RHODE ISLAND CONTRACT NO. 2006-CH-072

**Improvements To Interstate Route 195 Interim Shoring South Water Street On Ramp Bridge No. 524**

ADDENDUM NO. 3

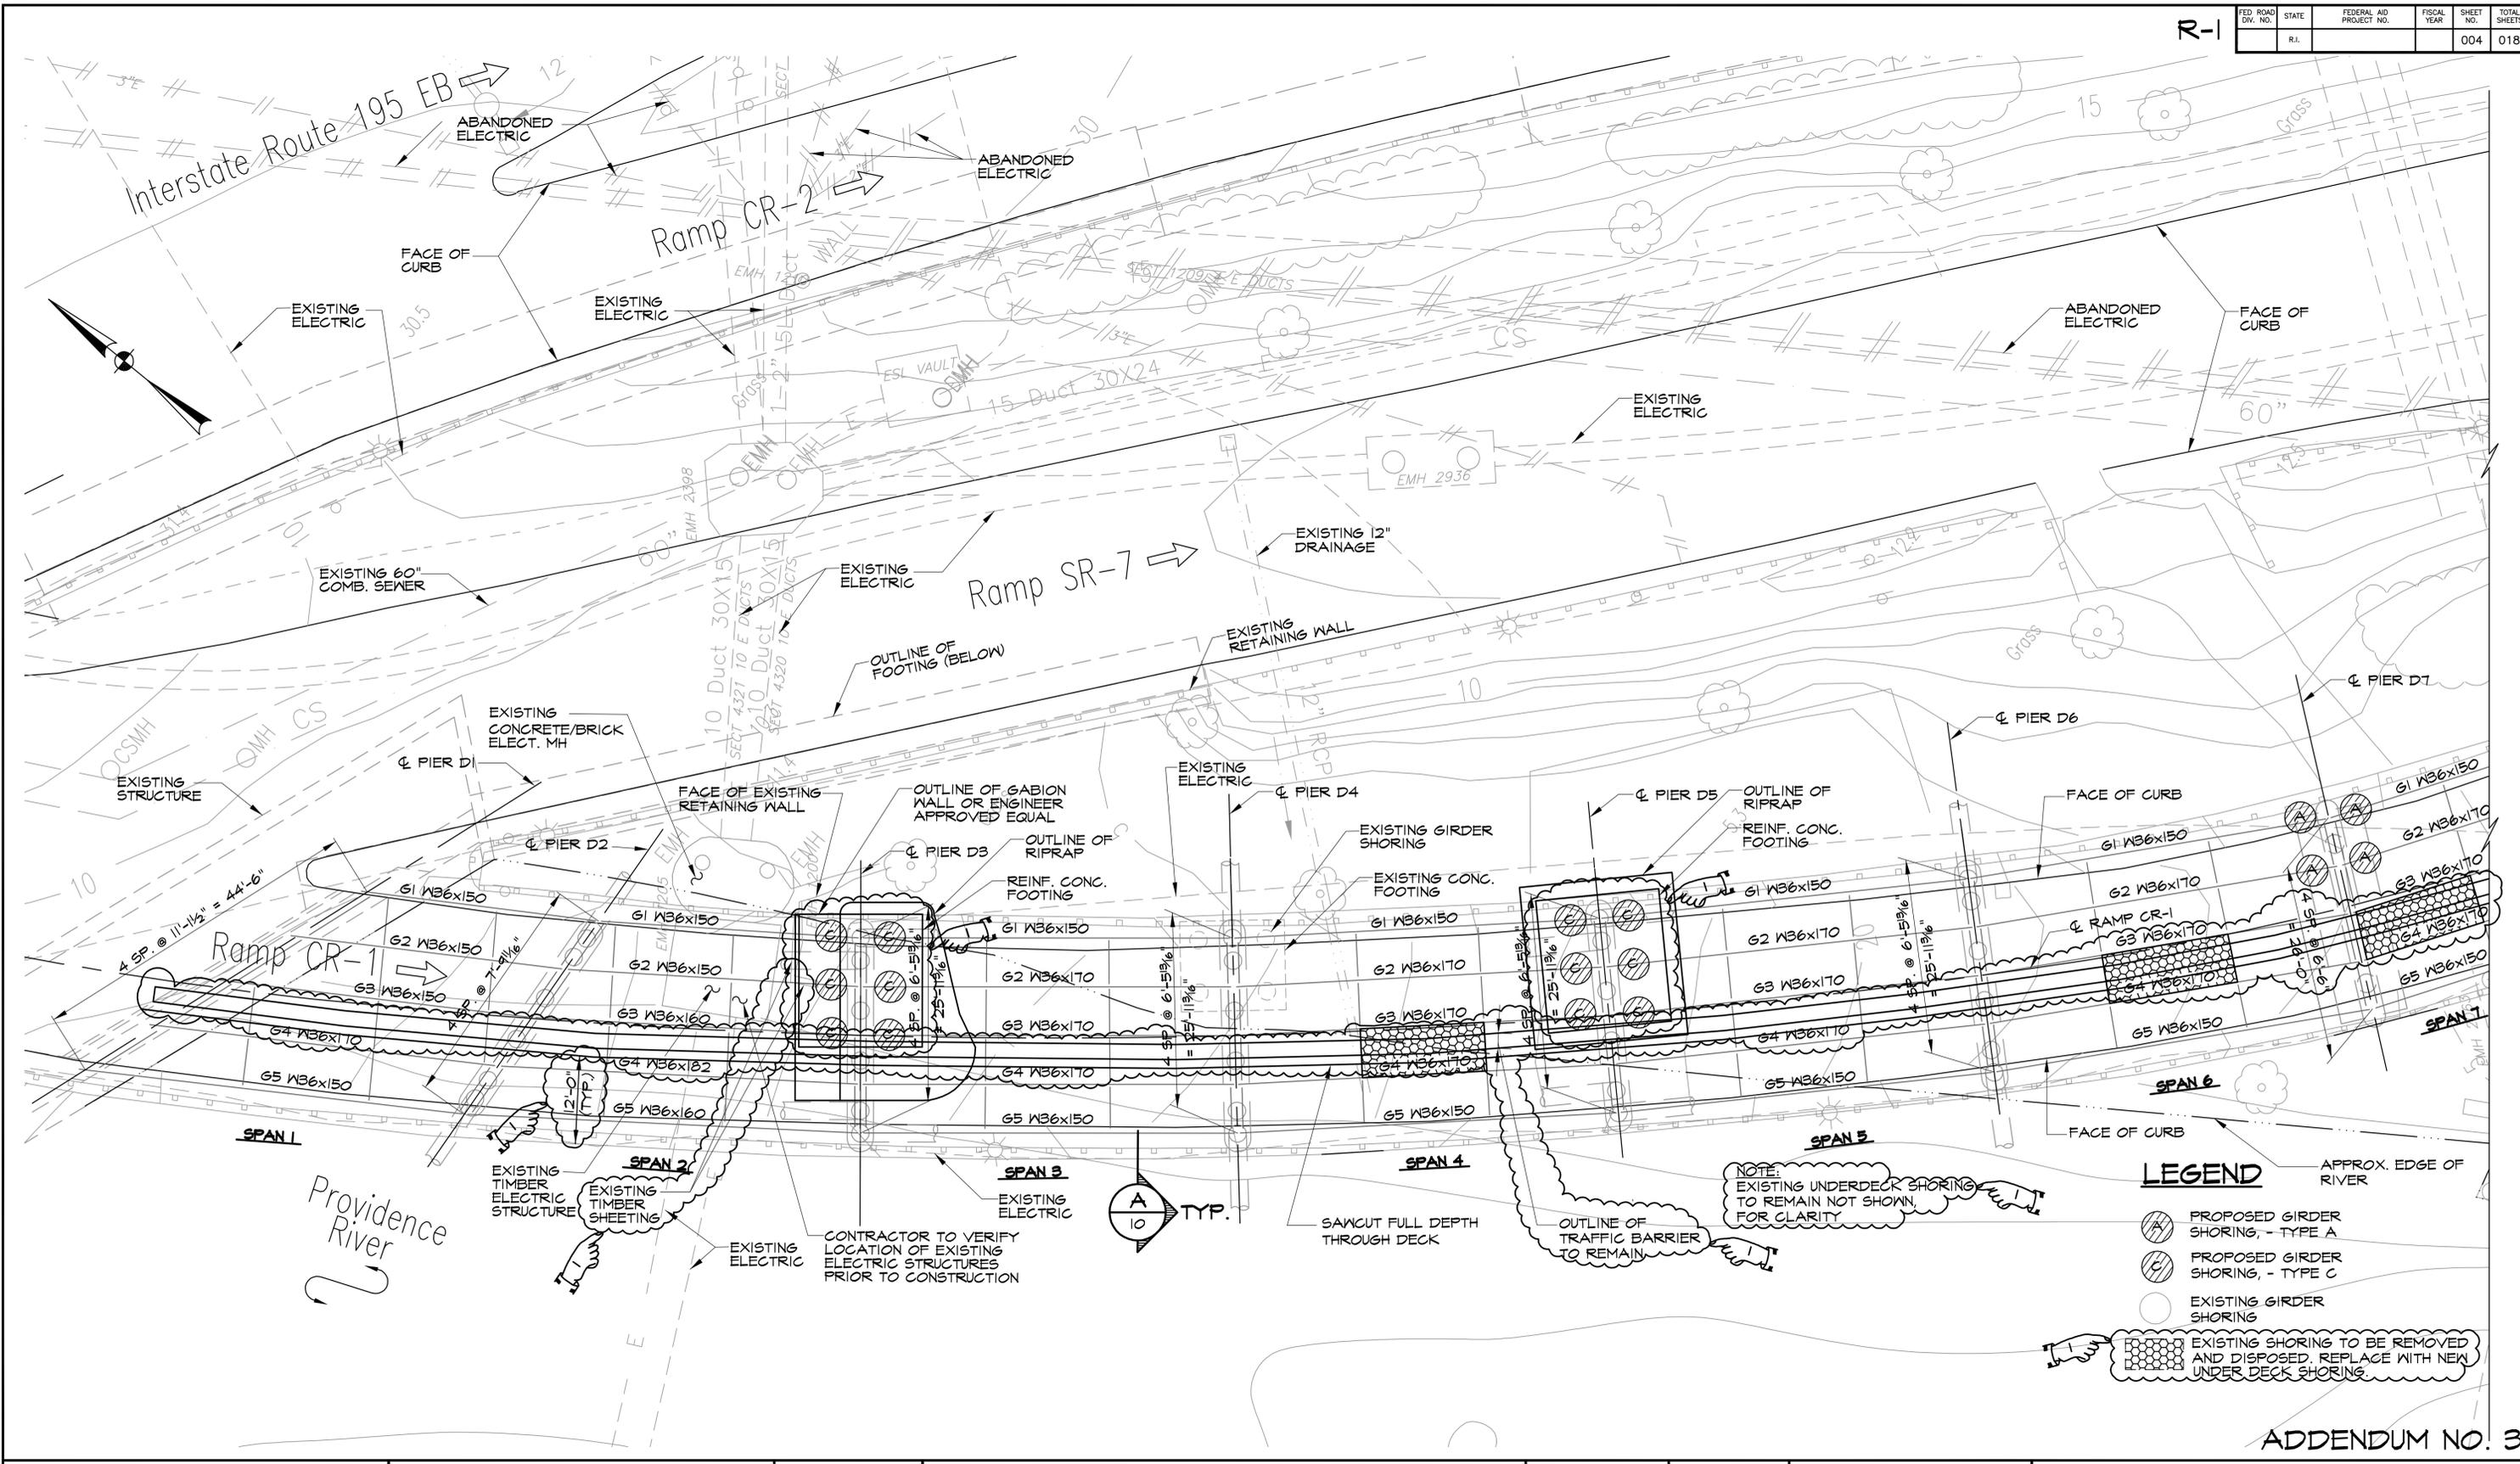
Delete General Notes in its entirety and insert revised General Notes attached to this Addendum. Material notes for timber, shop drawing requirements for timber and underdeck shielding, and underdeck shoring notes have been added.

**IMPROVEMENTS TO INTERSTATE ROUTE 195**  
 INTERIM SHORING  
 SOUTH WATER STREET  
 PROVIDENCE RHODE ISLAND  
 GIRDER SHORING PLAN 2  
 SO. WATER ST. ON RAMP BRIDGE, No.524  
 5

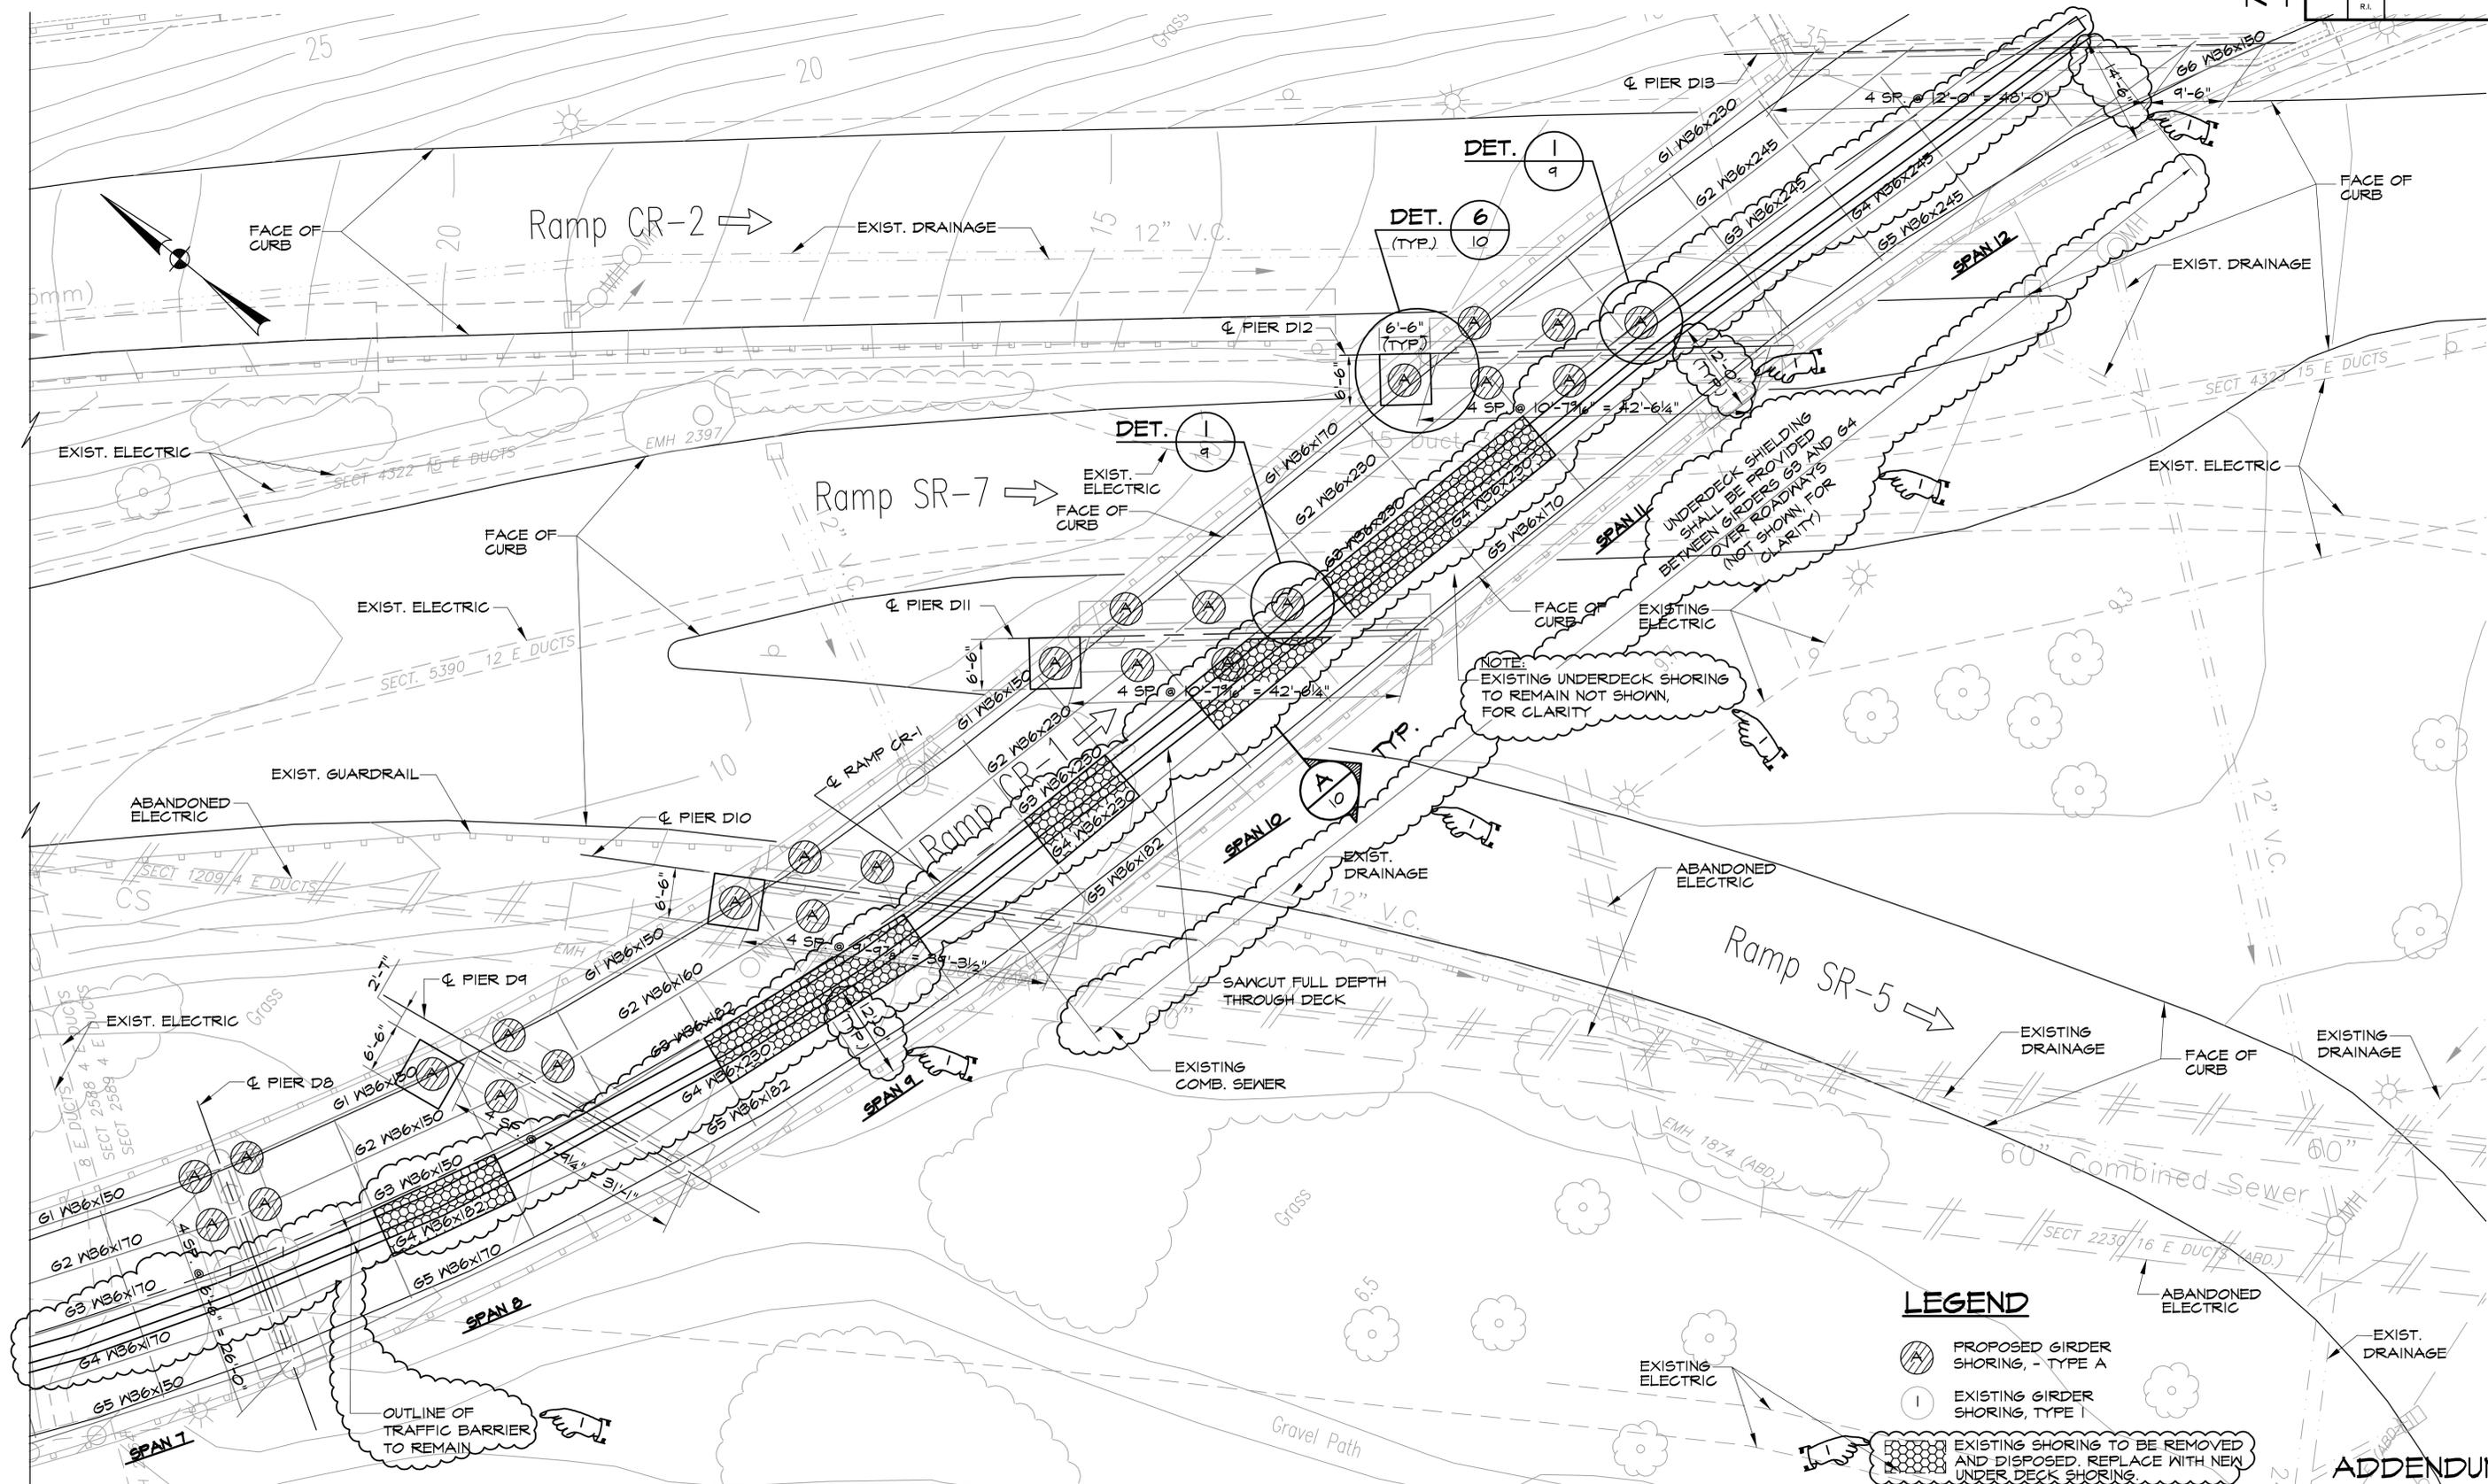
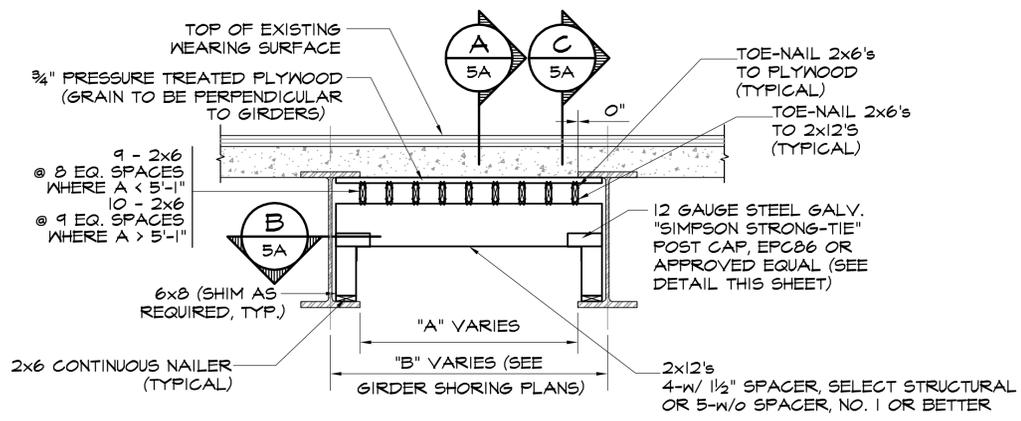
Delete Girder Shoring Plan, 2, So. Water St. On Ramp Bridge, No. 524 in its entirety and insert revised Girder Shoring Plan 2, So. Water St. On Ramp Bridge, No. 524 attached to this Addendum. The distance to the full depth saw cut in the deck has been revised. The outline of the traffic barrier to remain has been added. Areas of existing underdeck shoring to be removed, disposed and replaced have been highlighted, a related symbol added to the legend and the note that read 'EXISTING UNDERDECK SHORING NOT SHOWN, FOR CLARITY' with a leader has been revised to 'NOTE: EXISTING UNDERDECK SHORING TO REMAIN NOT SHOWN, FOR CLARITY' without a leader to indicate a general

description of the fact that underdeck shoring has not been shown unless it is being replaced. Limits of underdeck shielding to be provided have been added.
